**SERVICE BULLETIN No. 090**

## **Alternator Thru-Bolts**

1. This page transmits the revision of Service Bulletin (SB) 090 Rev. New to SB 090 Rev. A, dated May 25, 2022.
  - A. SB 090 Rev. New, dated April 27, 2022
  - B. SB 090 Rev. A, dated May 25, 2022
2. FAA approval has been obtained on technical data in this publication that affects type design.
3. Changes are shown by a change bar in the left or right margin coinciding with the change on the affected page.
4. This revision is issued to change the following:
  - A. Edits
    - (1) Remove serial numbers that are accounted for from Table 2.

Figure 1 - Thru-Bolt Locations

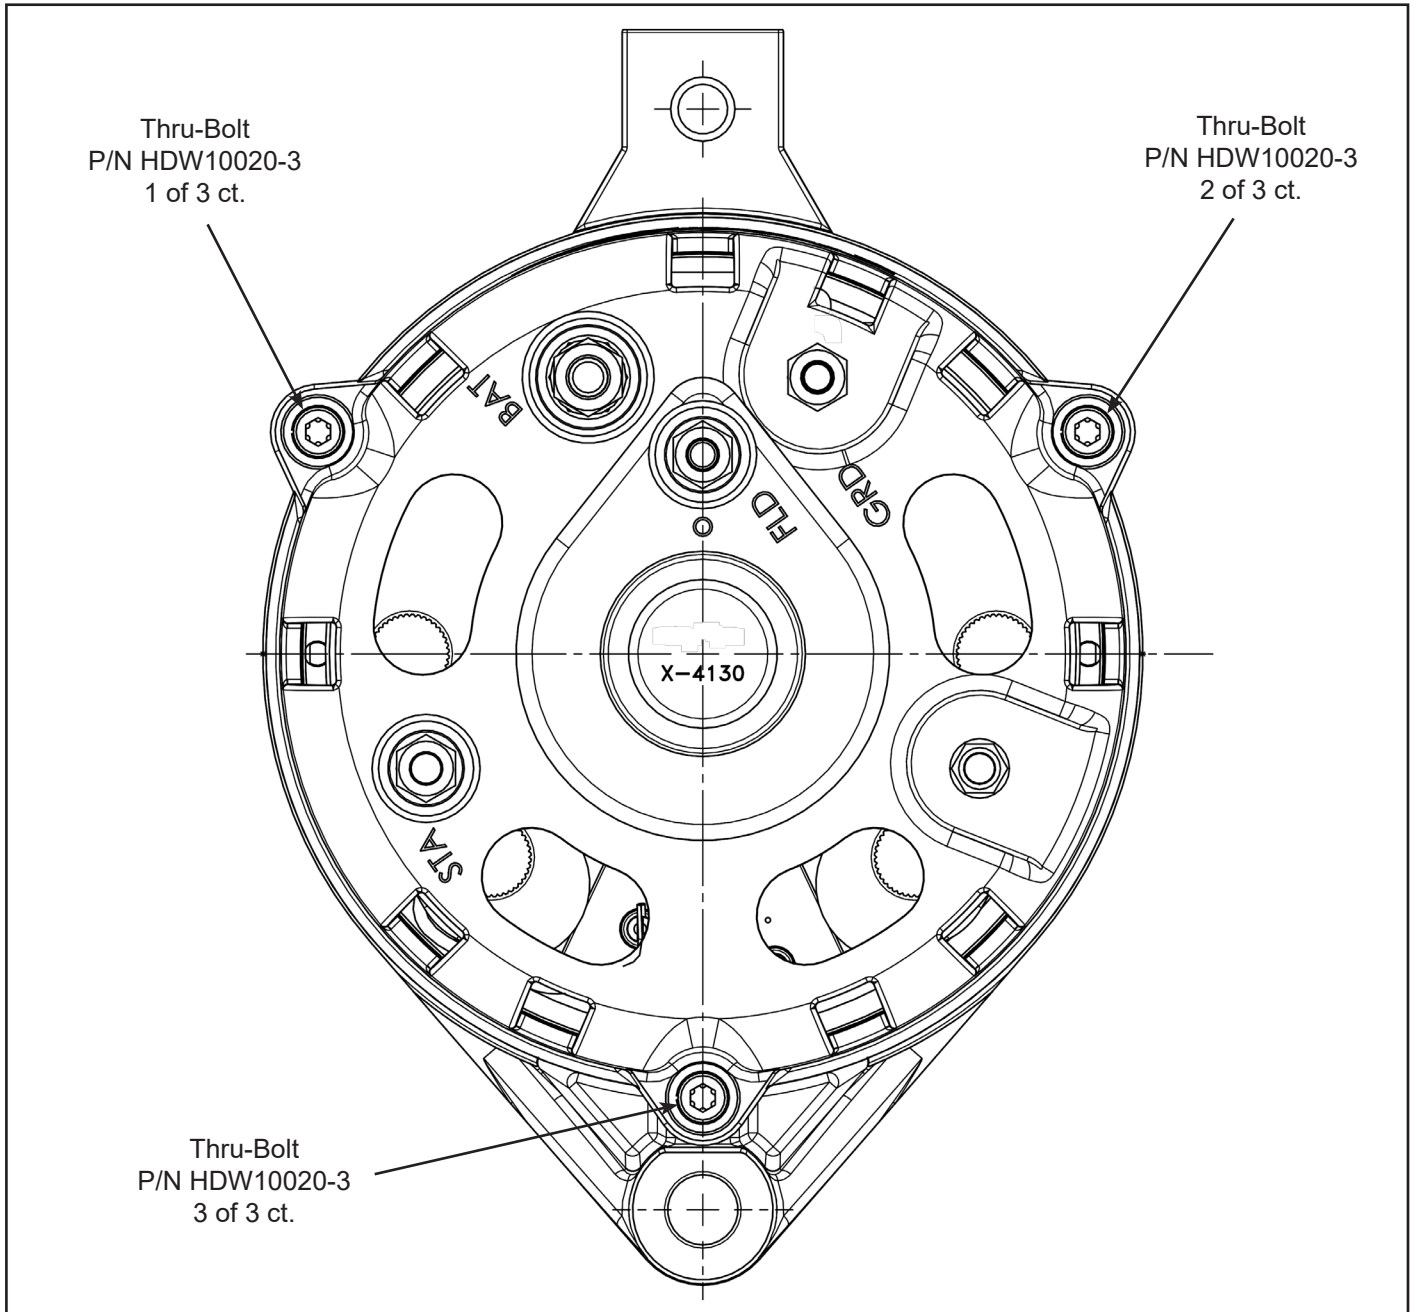
- (a) Gain access to the alternator in accordance with the latest revision of the aircraft and/or engine maintenance manual.
- (b) Visually inspect the three (3) thru-bolts (Fig.1) for evidence of cracks, broken safety-cable/wire, and/or sheared bolt heads. If indications are present, proceed to 3.B.2 and replace the alternator prior to further flight.
  - 1) If no cracks, broken safety cable/wire, or sheared thru-bolt heads are present, perform a recurring inspection every 25 aircraft-hours not to exceed one-hundred aircraft-hours from the initial inspection.
  - 2) At an accumulated one-hundred aircraft-hours or at the next scheduled annual aircraft inspection, whichever occurs first, the alternator must be replaced. See **Option 2**.

- (a) Remove the alternator from the engine in accordance with the latest revision of the aircraft and/or engine manufacturer's maintenance manual.
- (b) Install a new, overhauled, or repaired alternator in accordance with applicable engine manufacturer's maintenance manual. Refer to 2.A, Materials Required.
- (c) Reconnect alternator electrical connections and cooling hardware in accordance with applicable aircraft manufacturer's maintenance manual. Continue to 3.C. Return to Service.
